#2021-226

**GW Properties Wendy's and Guzman Y Gomez –
Final Planned Unit Development
Project Review for Planning and Zoning Commission**

<u>Meeting Date:</u>	January 19, 2022
<u>Request:</u>	Final Planned Unit Development for two new limited service restaurants.
<u>Location:</u>	5459 and 5501 Northwest Highway
<u>Acreage:</u>	Approximately 2.06 acres
<u>Existing Zoning:</u>	B-2 PUD General Commercial Planned Unit Development
<u>Surrounding Properties:</u>	North: B-2 PUD General Commercial South: M Manufacturing (Three Oaks Recreation Area) East: B-2 PUD General Commercial West: B-2 PUD General Commercial
<u>Staff Contact:</u>	Elizabeth Maxwell (815.356.3615)

SHEET NUMBER
A2.2

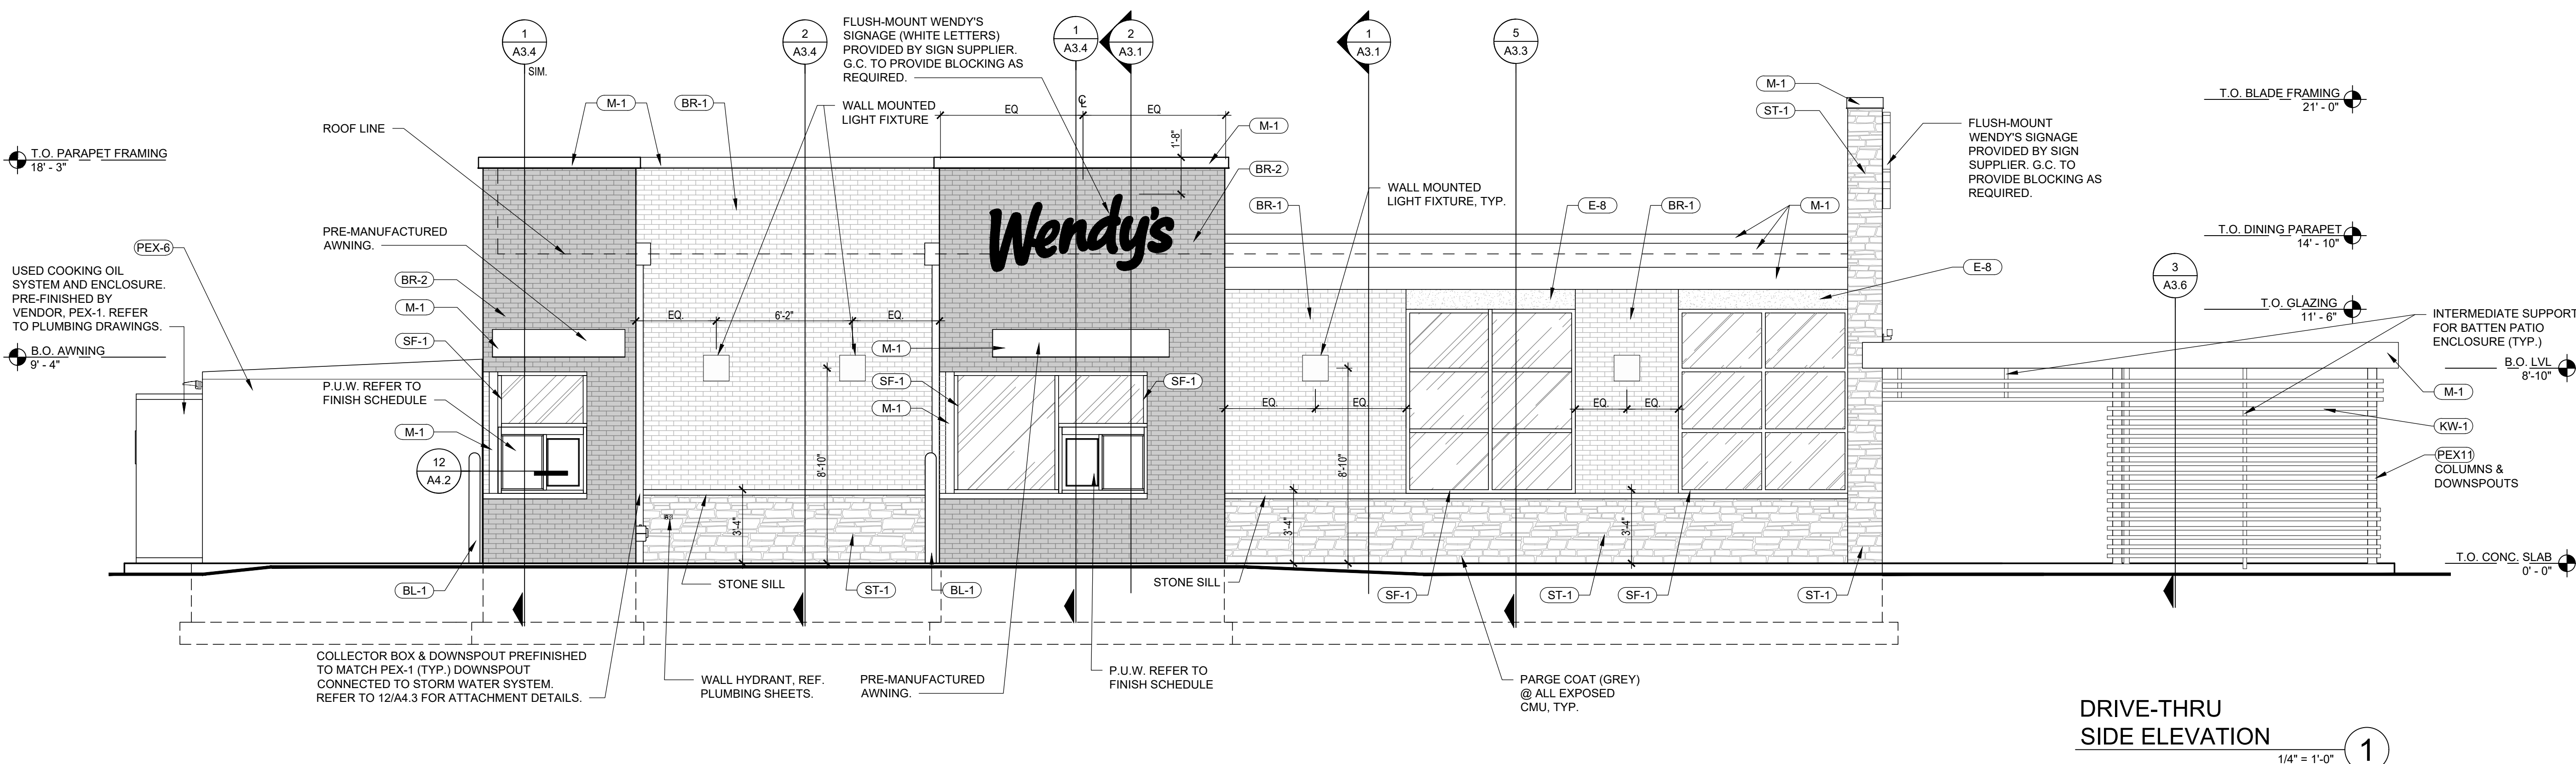
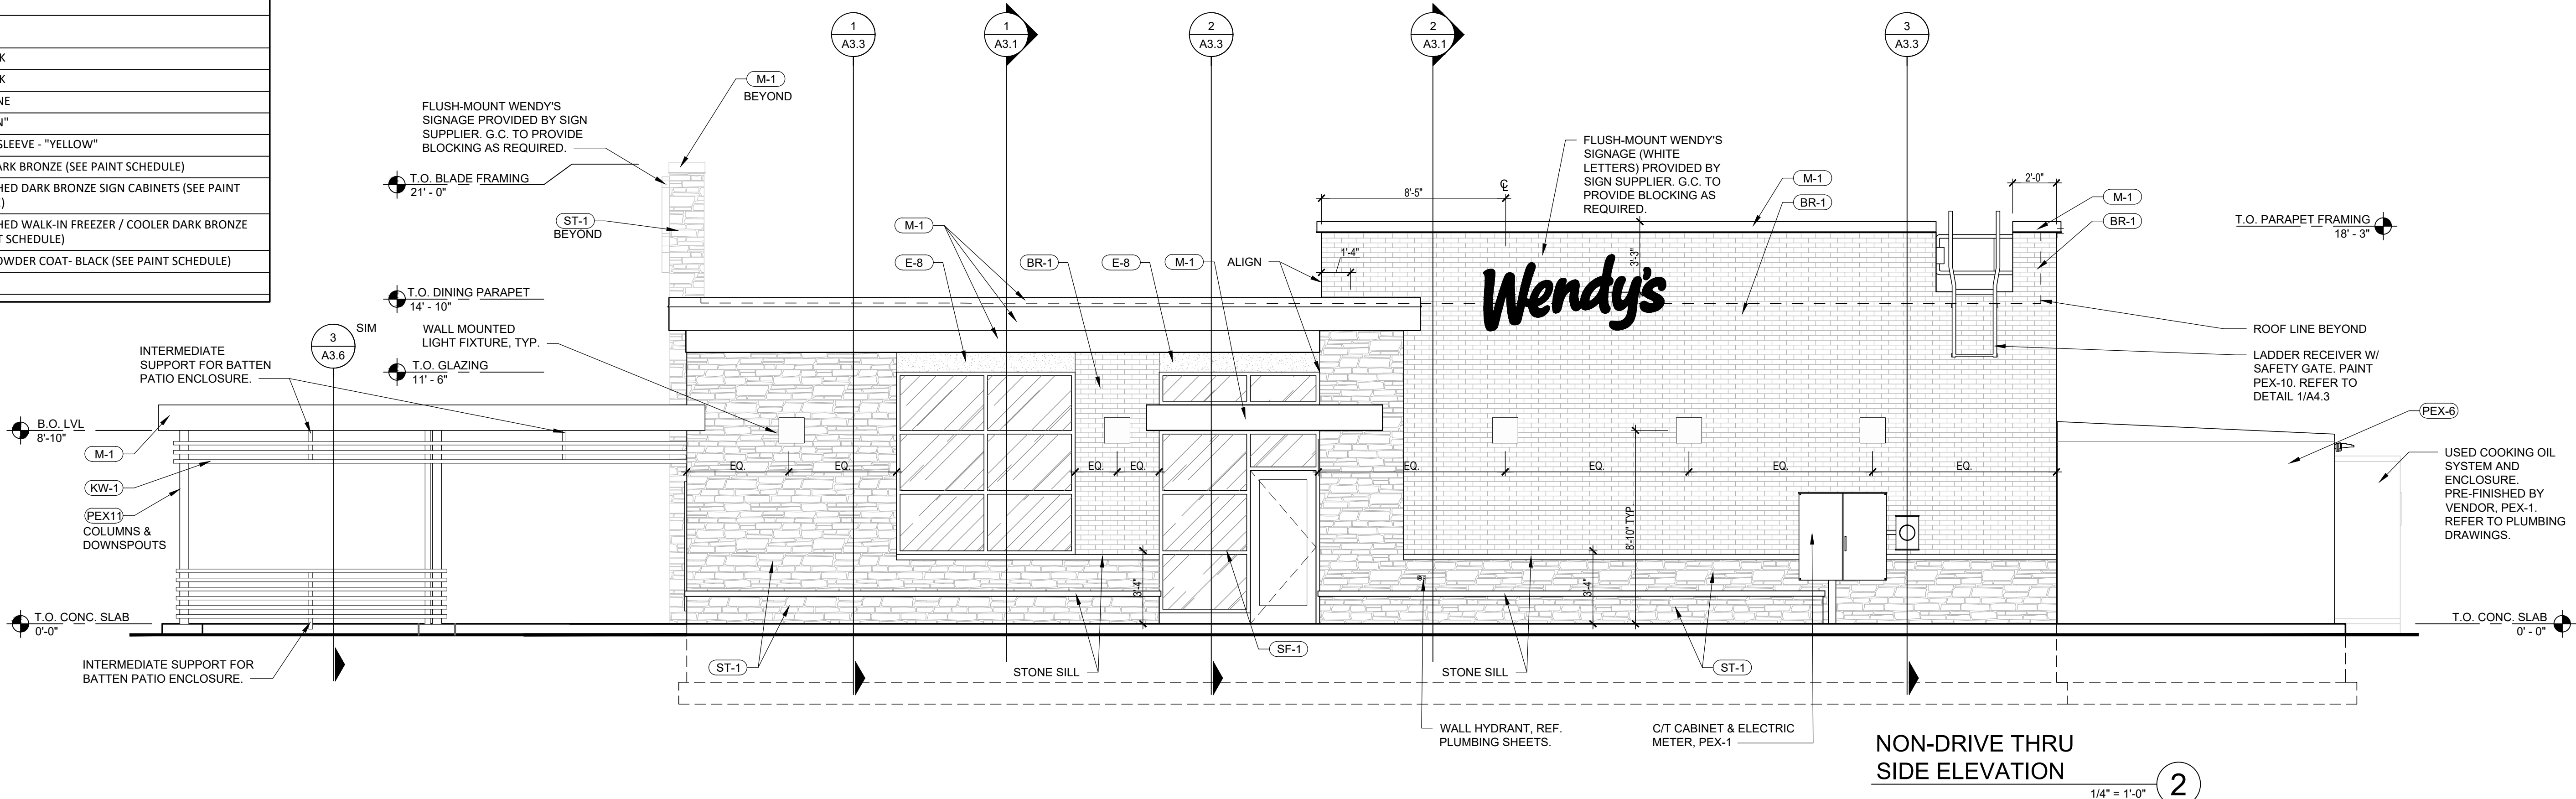
- Wendy's elevations have been revised to include the knee wall along the side elevations under the window bays and to install a canopy over the side elevation entrance.
- Guzman Y Gomez elevations have been revised to:
 - Install a yellow canopy over the entrance doors,
 - Break up the charcoal brick on the West and South elevations with some additional Alamo colored brick,
 - Increased the width of the framing around the doors,
 - Added horizontal framing members to the windows, and
 - Installed soldier course brick of two rows along the tower element and one row under the remainder of the top cap giving the top a much thicker and finished look.

- G. Traffic Impact Study (Gewalt Hamilton, updated 6/30/21, received 12/21/21)
2. Conditions from Ordinance 7721 shall remain applicable unless modified by this request.
3. Elevations
 - A. Wendy's to install one or two rows of soldier course brick approximately 1/3 down from the top of the parapet on the rear portion where the building increases in height to help break up the expanse of brick.

- B. The Guzman Y Gomez brick color shall be Yankee Hill Matte Charcoal.
 - C. On the Guzman Y Gomez building the soldier course brick under the top cap should project at least 1 inch beyond the main portion of the elevation and the top cap should project at least 1 inch beyond this brick.

3 MONUMENT SIGN ELEVATION
A4.20 SCALE: 1/4" = 1'-0"

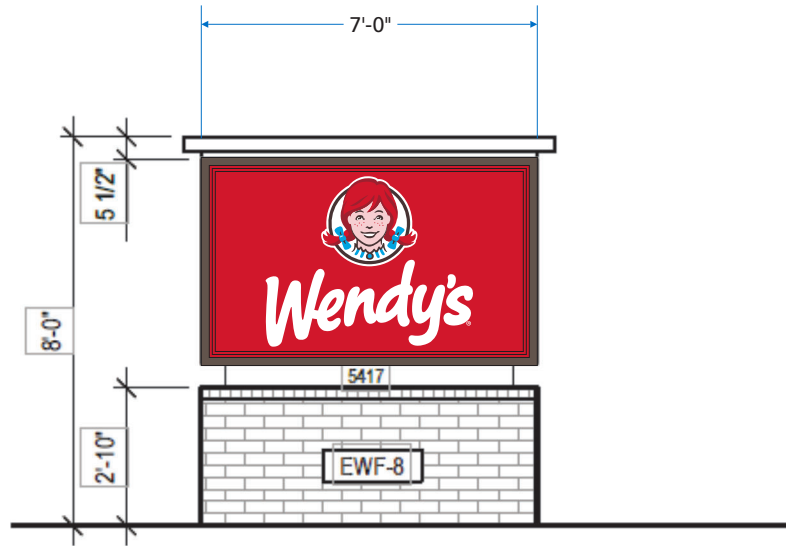
6. The Wendy's monument sign brick shall match the brick of the building.
7. The petitioner shall address all of the review comments and requirements of the Community Development, Fire Rescue, and Public Works Departments, as well as the City's Stormwater Consultant and the final approved Traffic Study.

1 SITE PLAN - OVERALL
 1" = 40'-0"

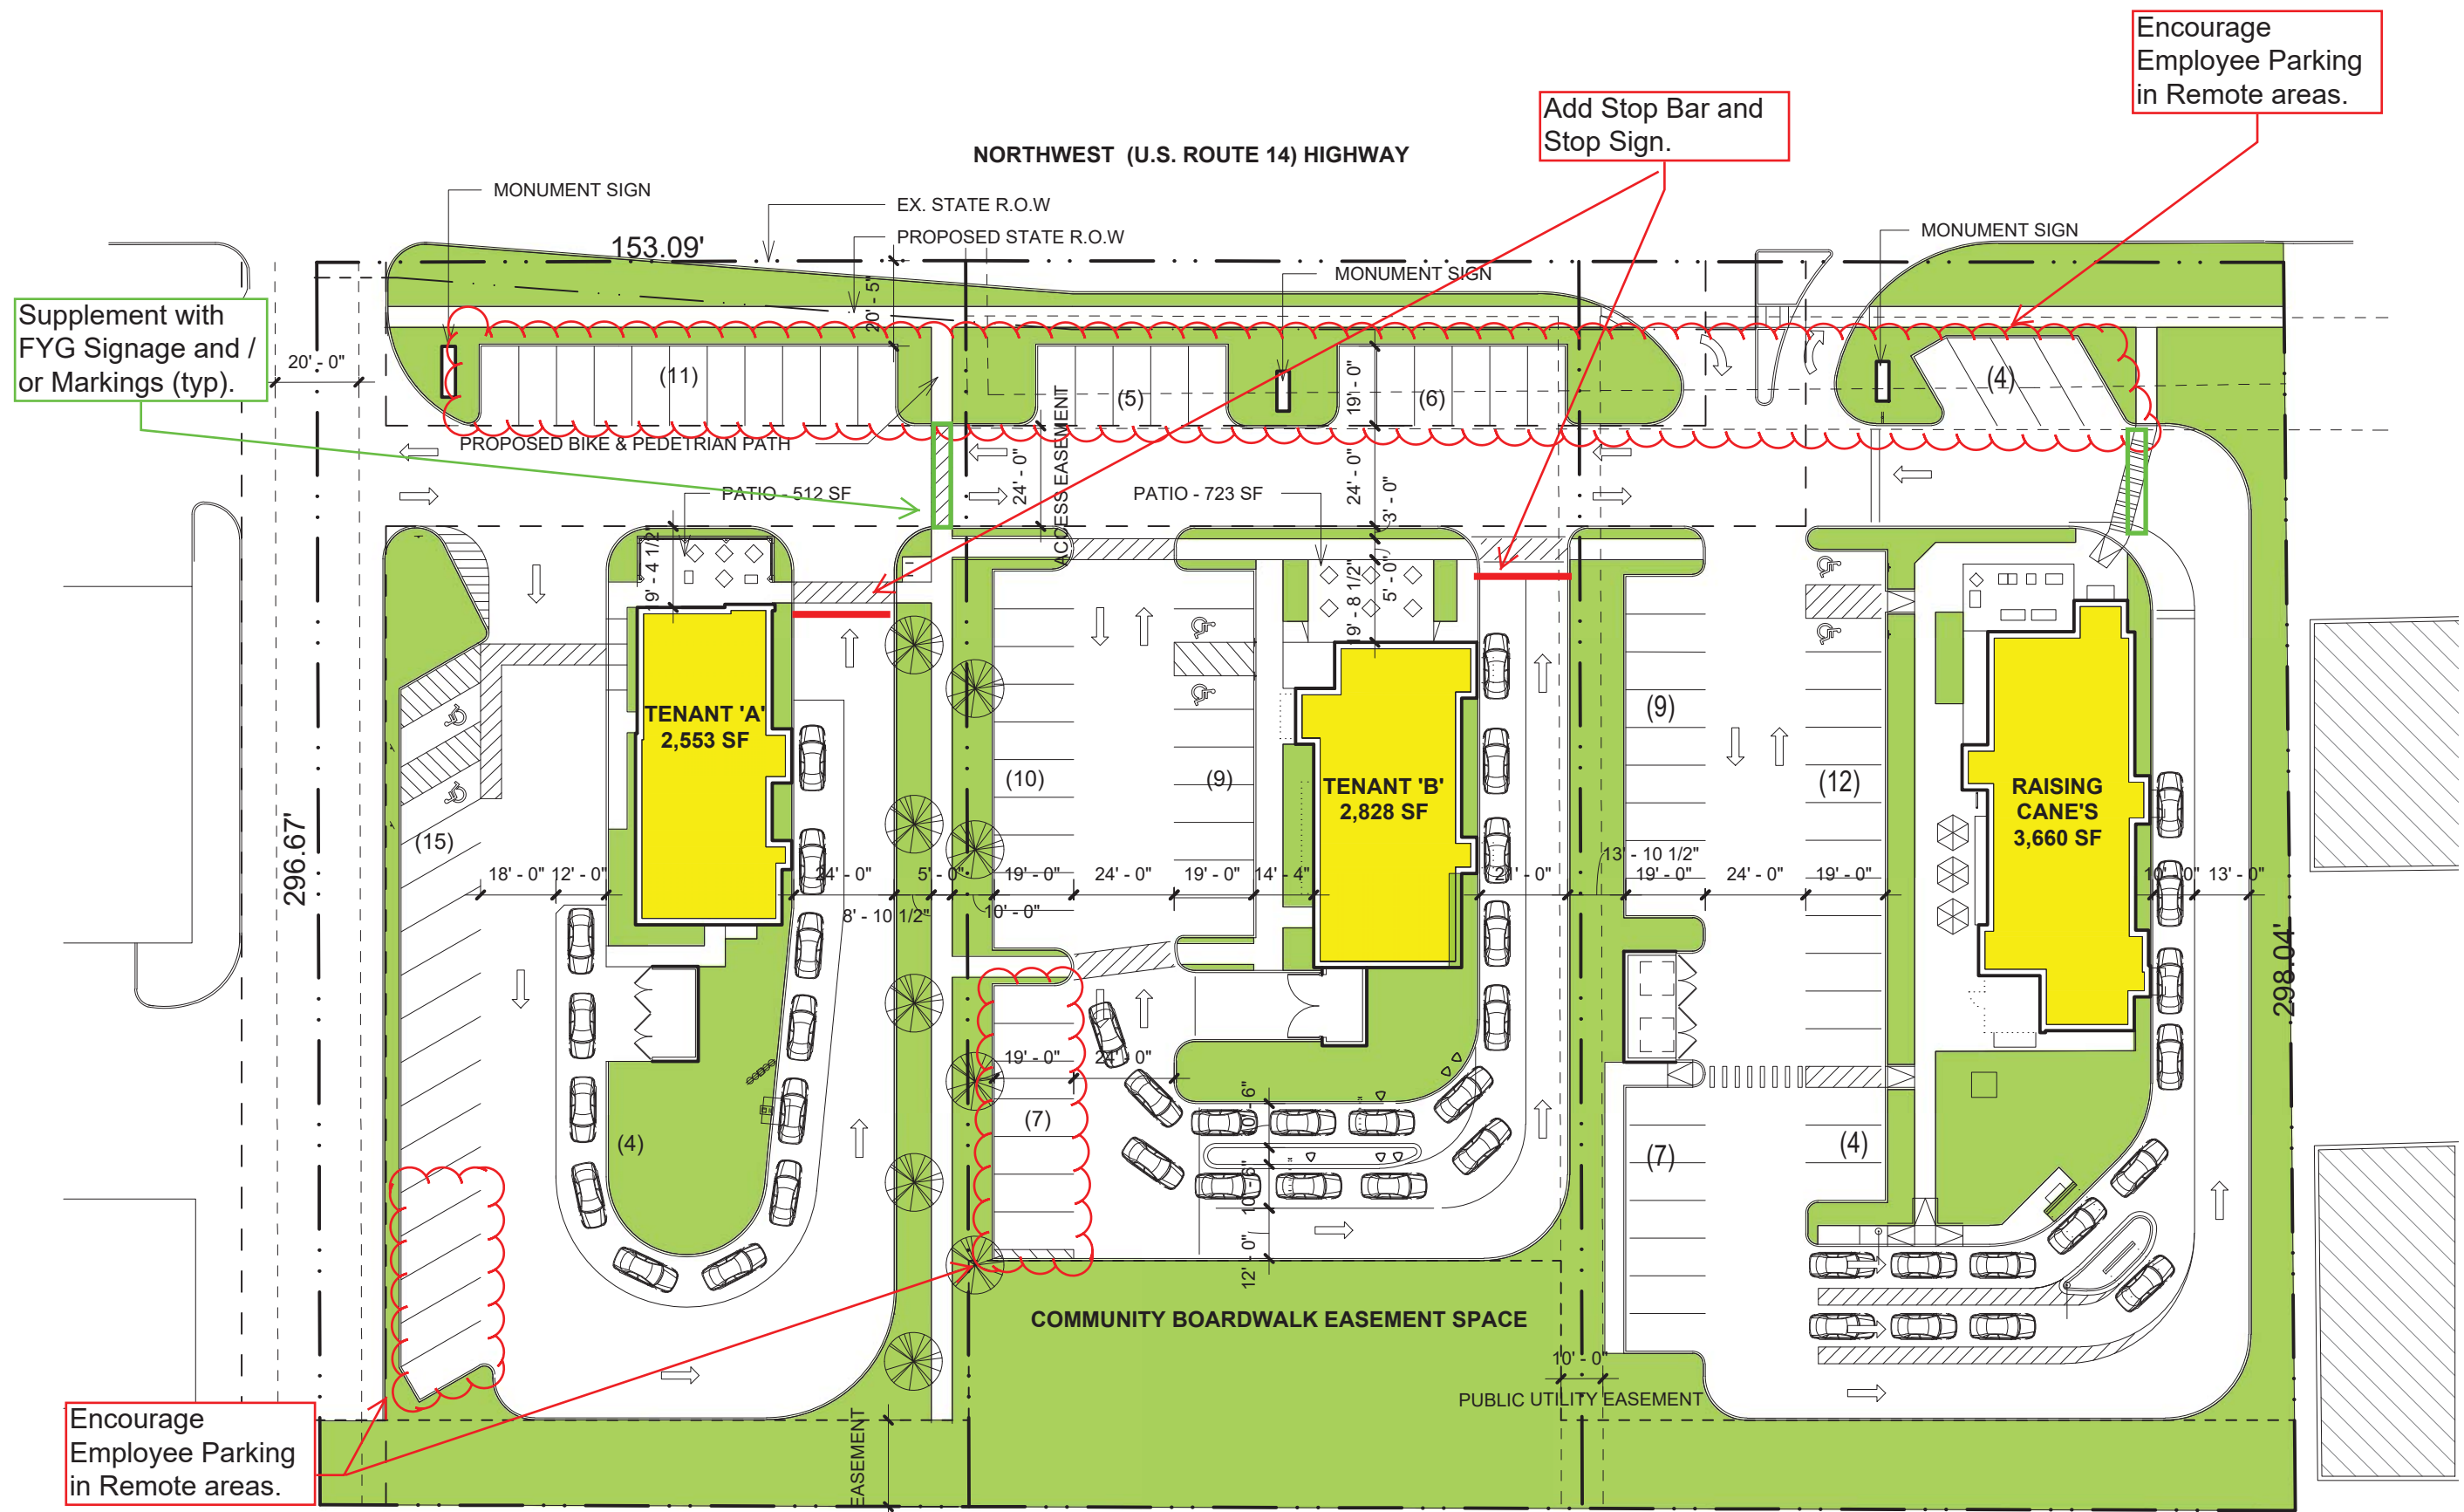
- Enhanced warning signage for the pedestrian connections to the proposed sidewalk along US Route 14 (e.g., fluorescent yellow-green signs and markings).
- Provide Stop Signs and Stop Bars along exit drives in advance of the pedestrian crossings that parallel US Route 14.
- Provisions for bicycle parking / bike racks should be included on the site plans or in a common area adjacent to the future boardwalk easement.

- Consider supplemental signage instructing riders to dismount and walk bikes upon entering the various restaurant sites to help minimize conflicts with motorists.
- Ensure plantings and landscaping is kept to ground level in the vicinity of crossing locations to preserve sight lines for pedestrians.

Exhibit 10 identifies some of our recommendations on the current proposed site plan.

- A Stop sign would be installed on the shared site access driveway, opposite Federal Drive. This site access should be widened slightly to the east to provide one inbound lane and two outbound lanes. Exiting lanes should be marked as a separate left-turn lane and a shared through/right-turn lane. The proposed three-quarter site access driveway on US Route 14 should provide one inbound lane and one outbound (right-turn) lane, operating under Stop sign control.

- The entrance to the Wendy's site should provide a raised "truck apron" to give the appearance of a narrower entrance drive to help limit speed of inbound vehicles while still accommodating the larger delivery vehicles needed.
